**DOCUMENT 00 91 03  
ADDENDUM NO. 3**

PROJECT: 2024 Smith and Spillane MS Renovations  
BID DATE: **Thursday, February 20, 2025 (no Change)**  
FROM: Carolina Weitzman, A.I.A.  
Natex Corporation Architects  
447 Heights Blvd, Houston, TX 77007  
TO: **Prospective Bidders**

**MECHANICAL CONTROLS SECOND FLOOR PLAN**  
**M5.03**

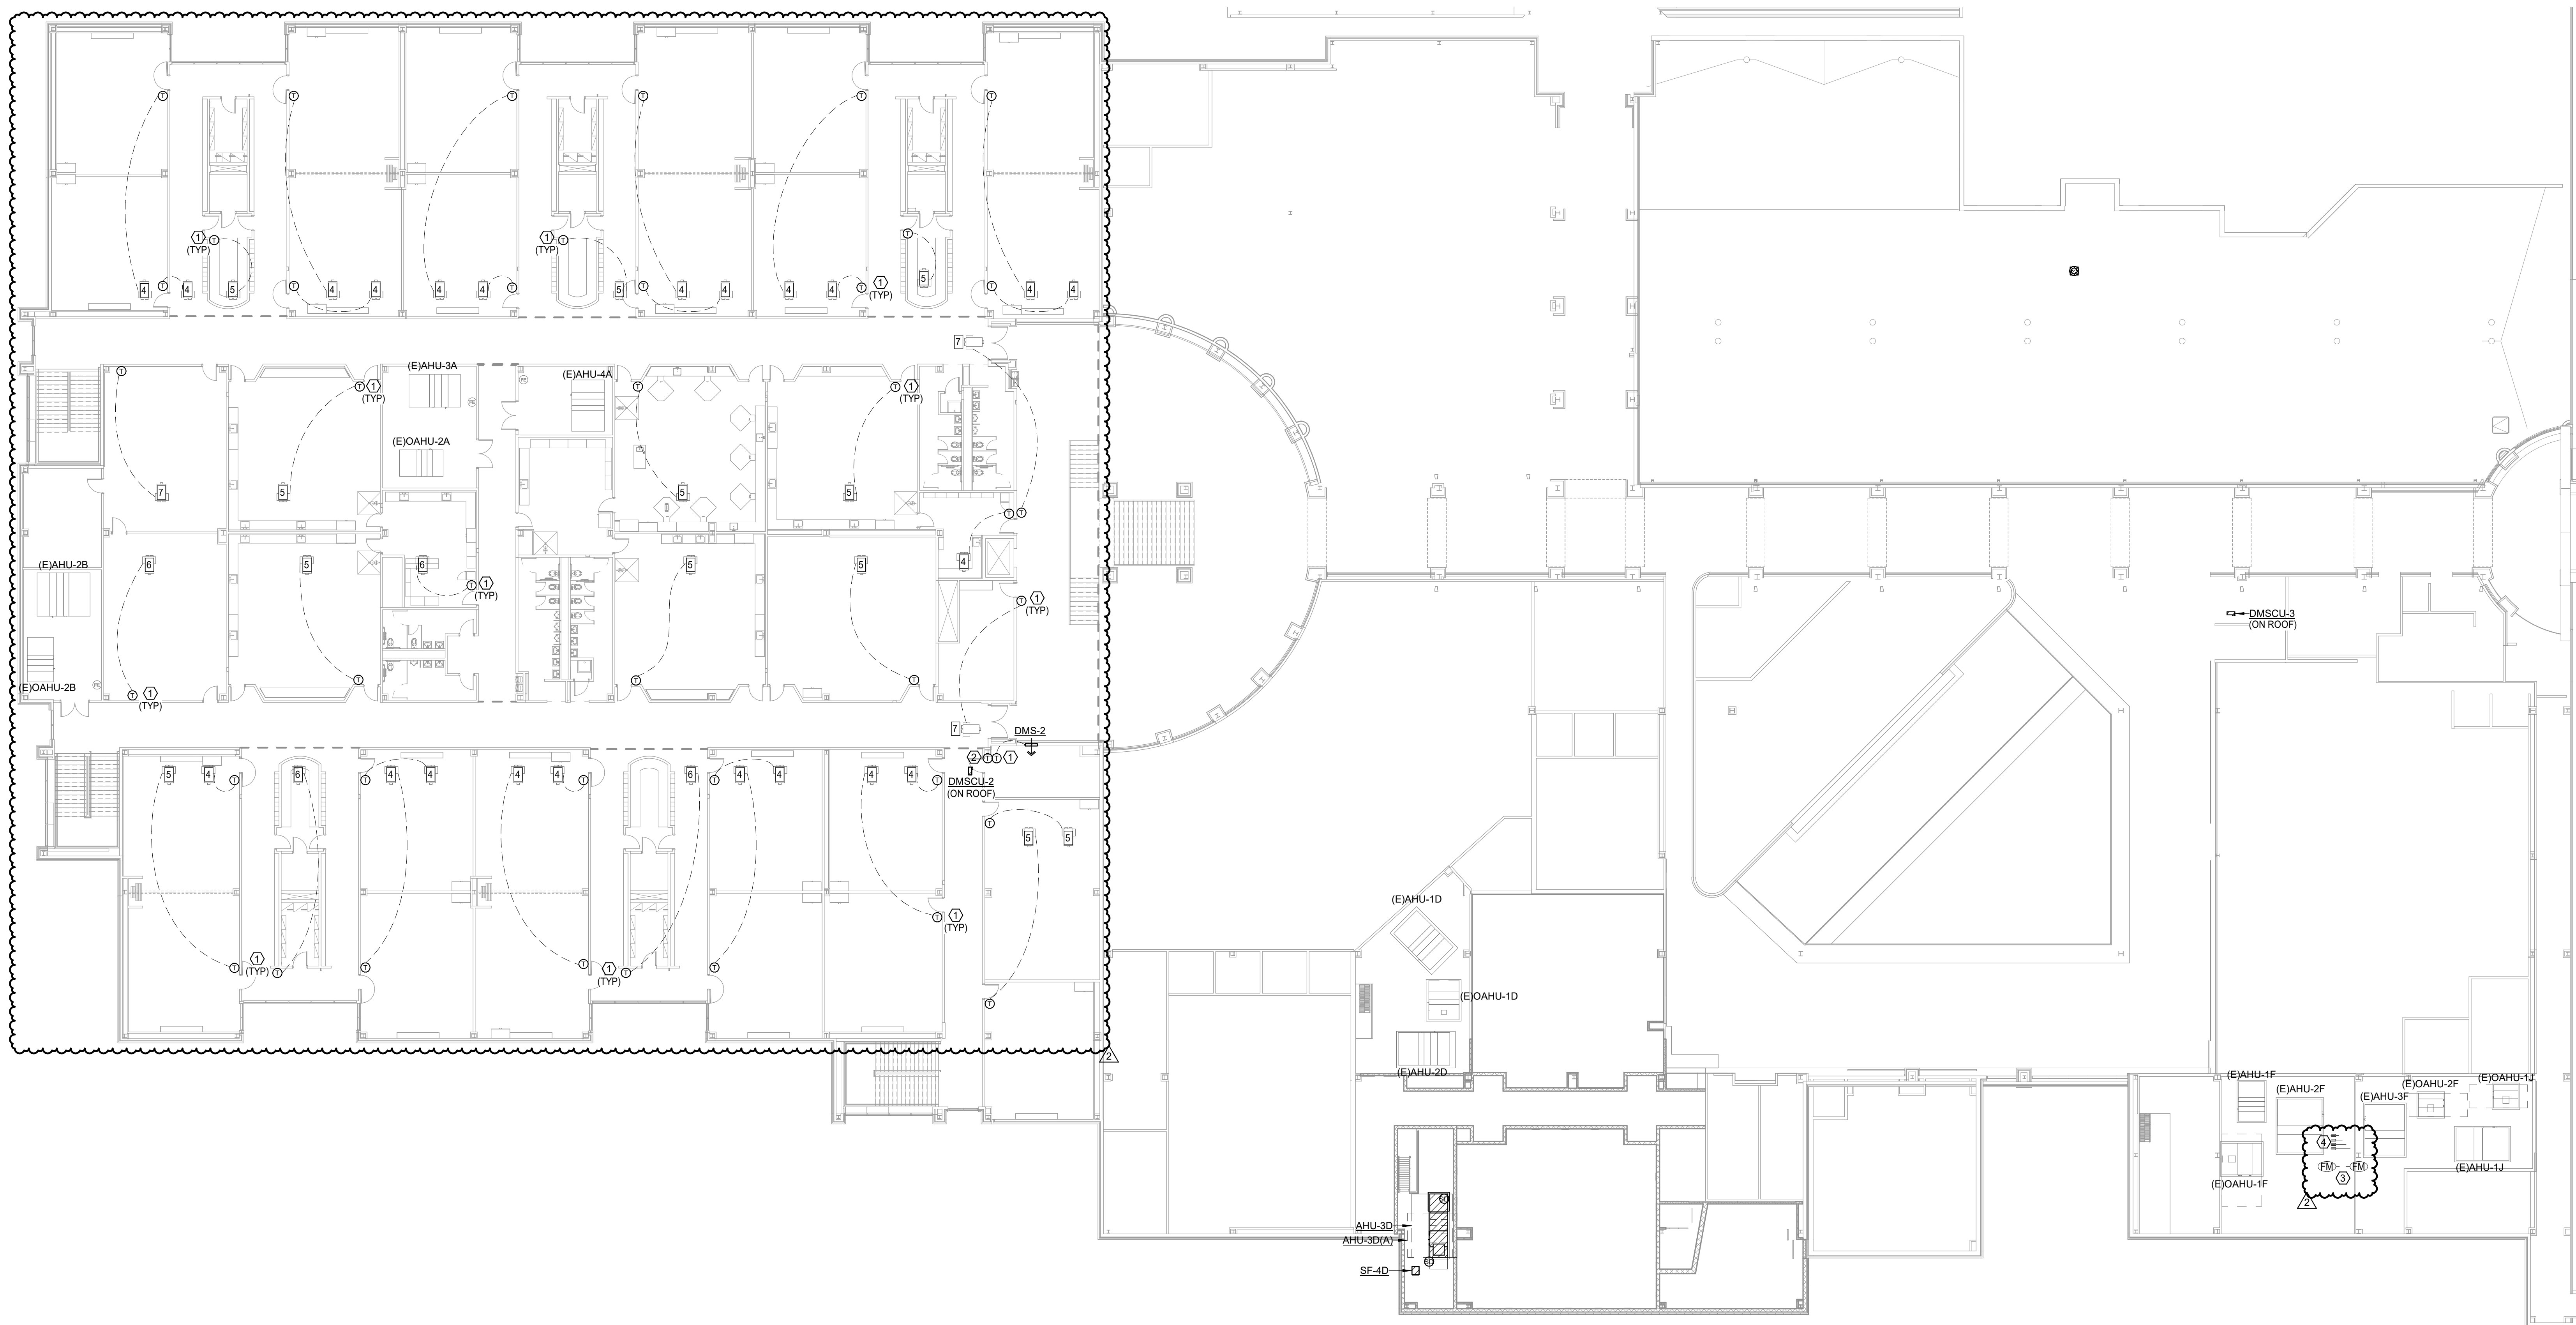
9. M5.02 MECHANICAL CONTROLS FIRST FLOOR PLAN – AREA E,F,G,H,J
  - a. Refer to revised plan for additional controls scope.
10. M5.03 MECHANICAL CONTROLS SECOND FLOOR PLAN

- a. Refer to revised plan for additional controls scope.
11. M5.04 MECHANICAL CONTROLS PLAN – CENTRAL PLANT
  - a. Refer to revised plan for additional controls scope.

Project Number: 23073  
 Date: 26 JANUARY 2025  
 Drawn By: WHL / KLO  
**ELECTRICAL LIGHTING**  
**FIRST FLOOR PLAN -**  
**AREA 'D'**  
**E2.04**

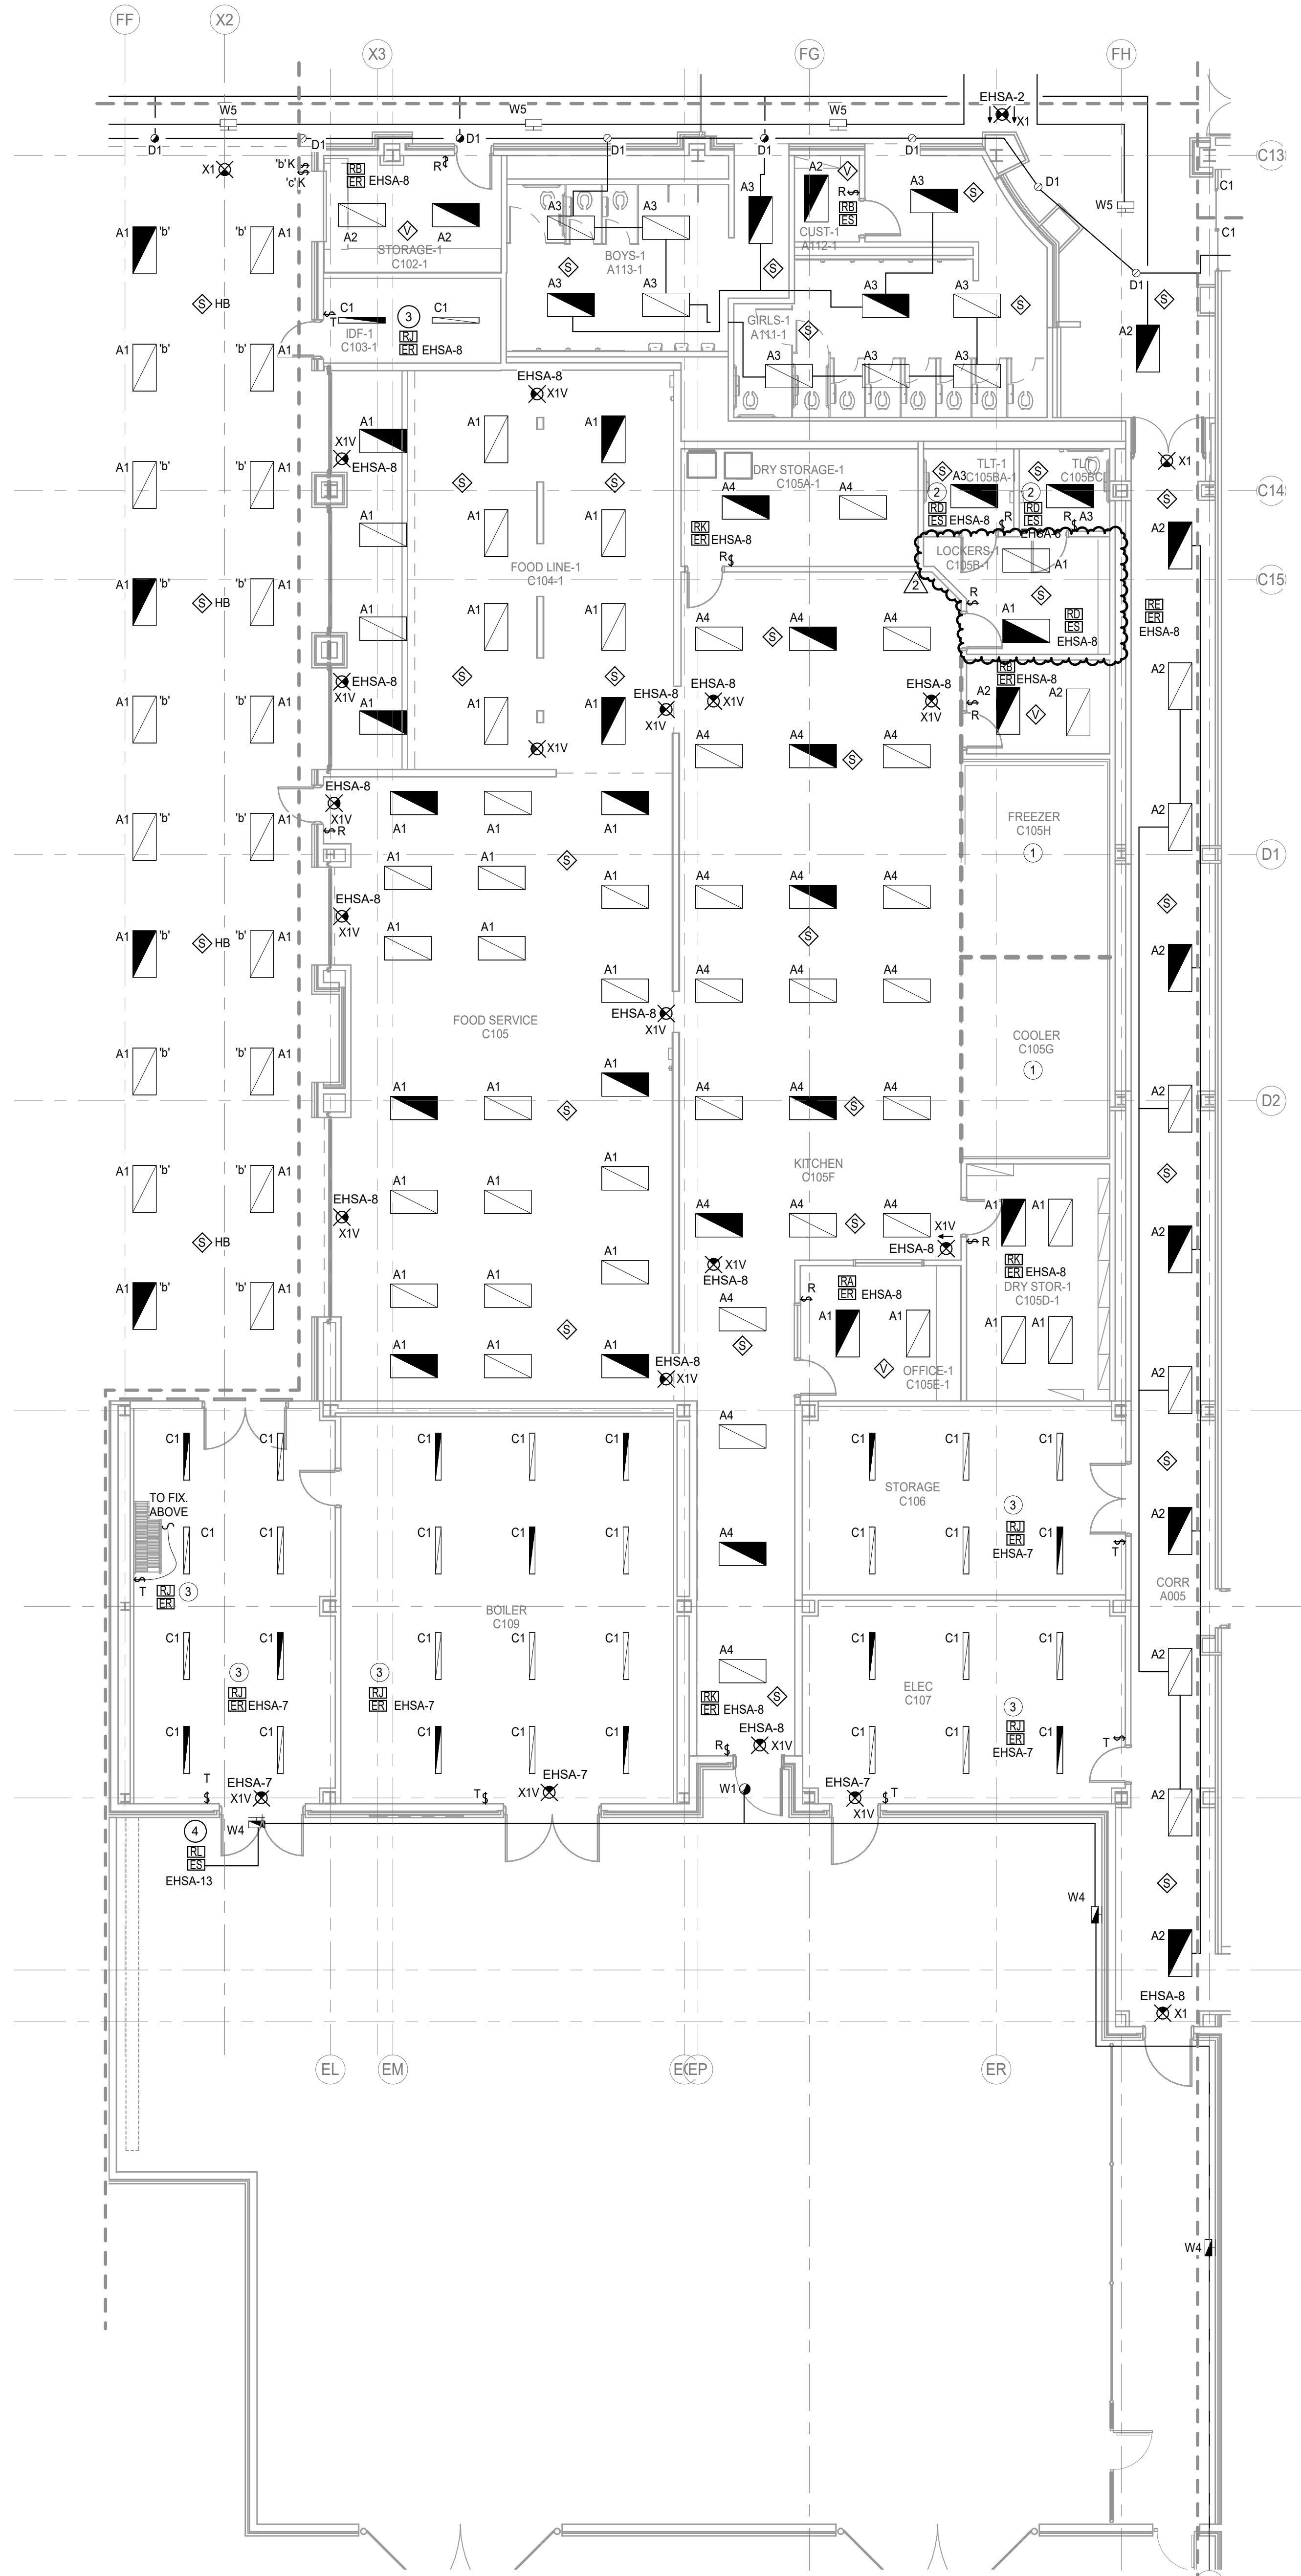
- a. Lighting layout revisions as noted.
18. E2.06 - ELECTRICAL LIGHTING FIRST FLOOR PLAN -AREA 'F'
  - a. Lighting layout revisions as noted.
19. E2.08 - ELECTRICAL LIGHTING FIRST FLOOR PLAN -AREA 'H'

Project Number: 23073  
 Date: 26 JANUARY 2025  
 Drawn By: WHL / KLO  
**ELECTRICAL LIGHTING**  
**SECOND FLOOR PLAN -**  
**AREA 'B'**  
**E2.11**

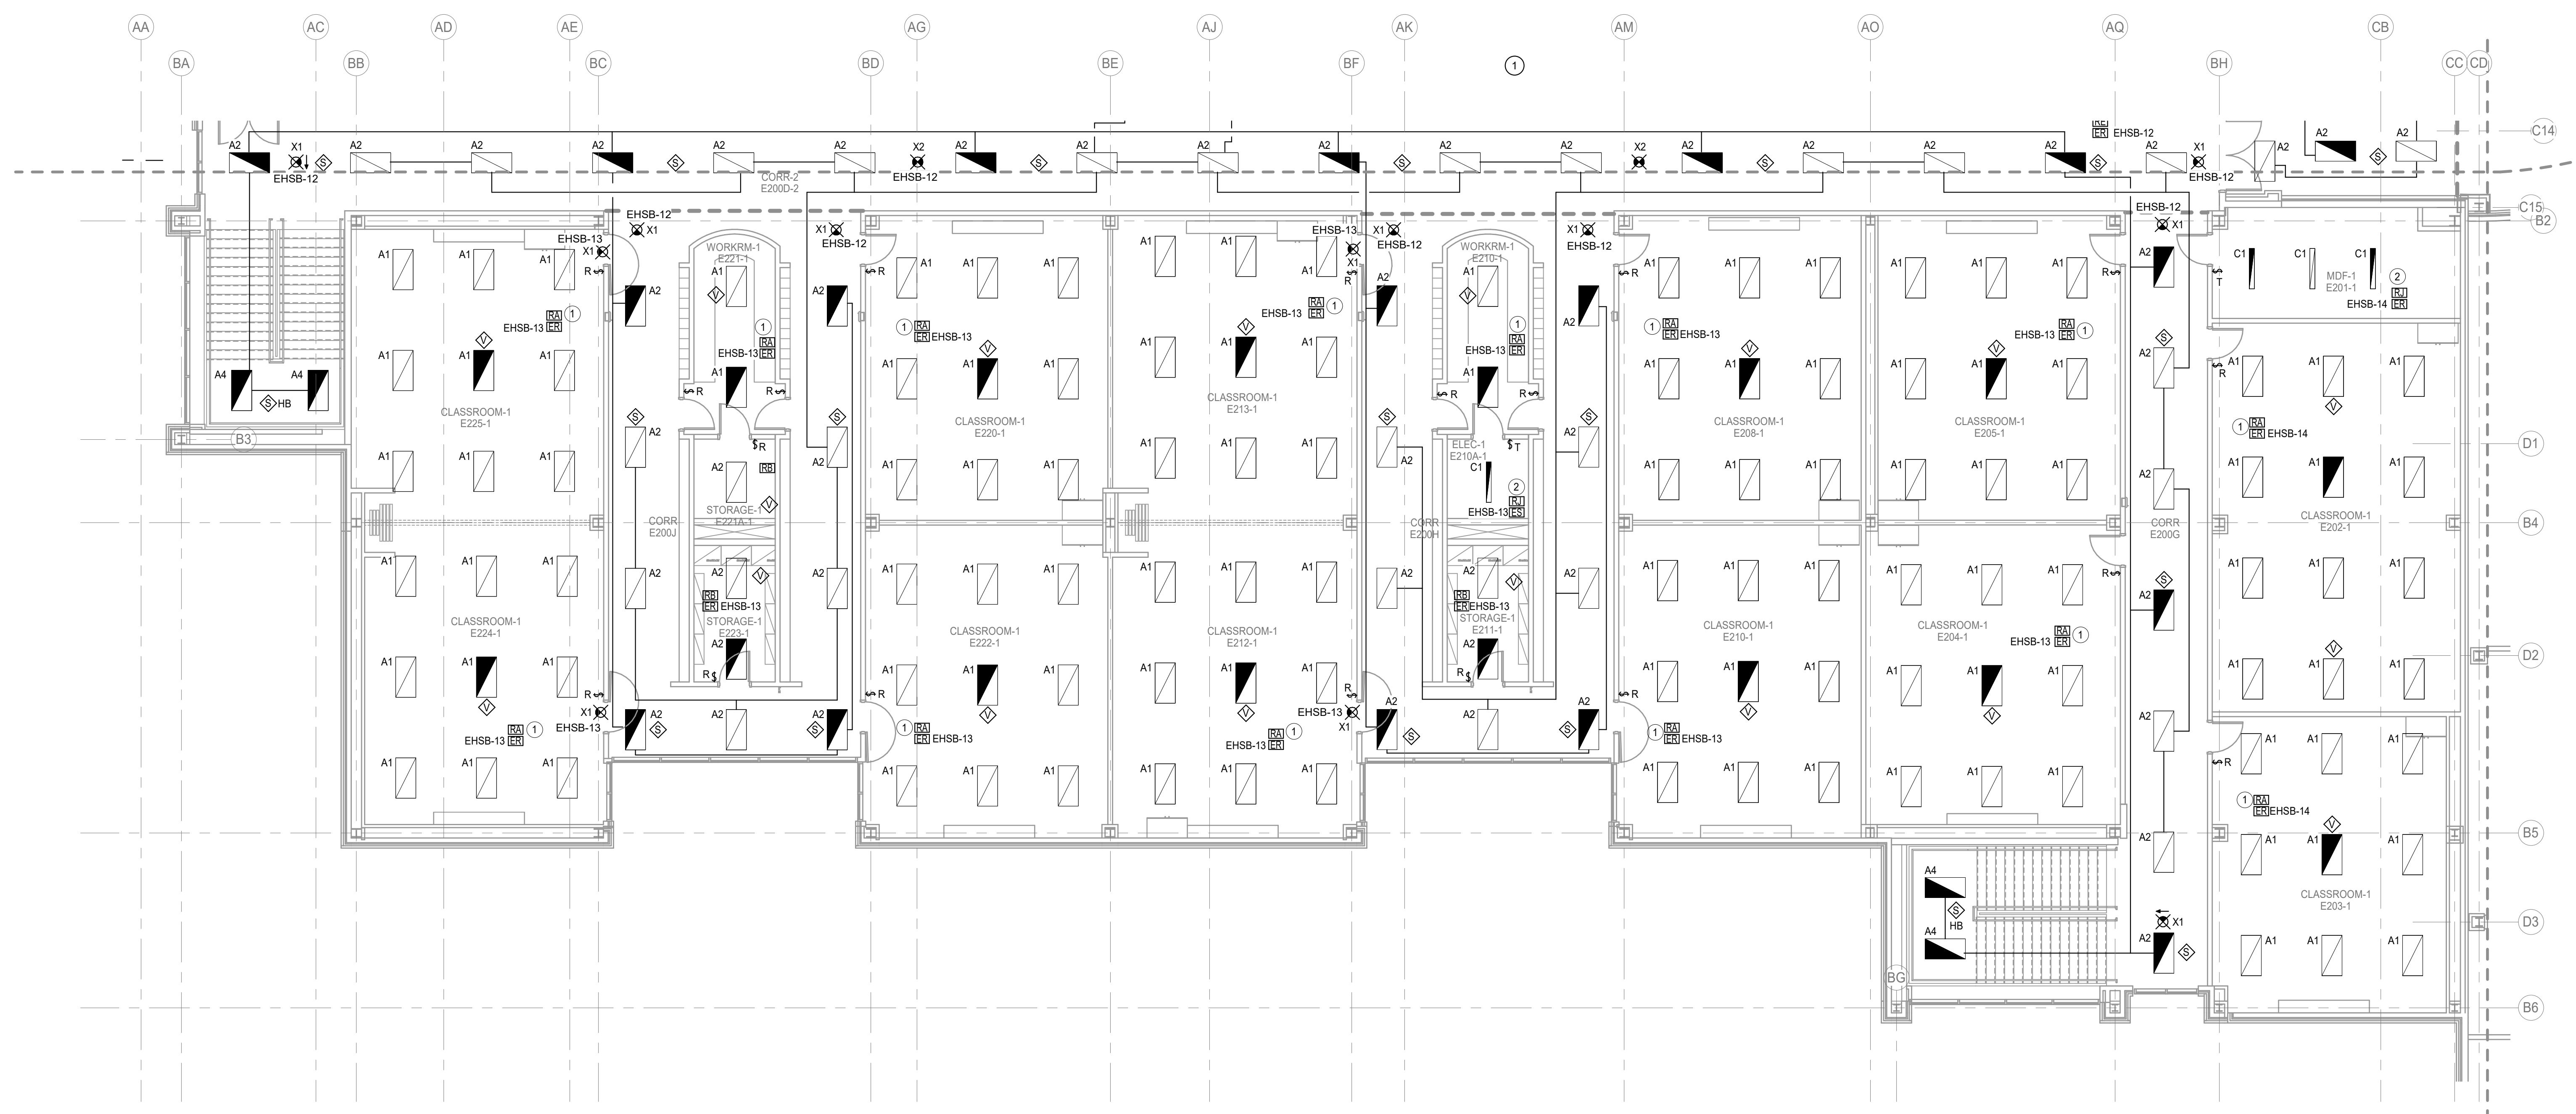
- a. Lighting layout revisions as noted.
22. E3.03 - ELECTRICAL POWER FIRST FLOOR PLAN -AREA 'C'
  - a. Power provided for new Kiln EF-1.
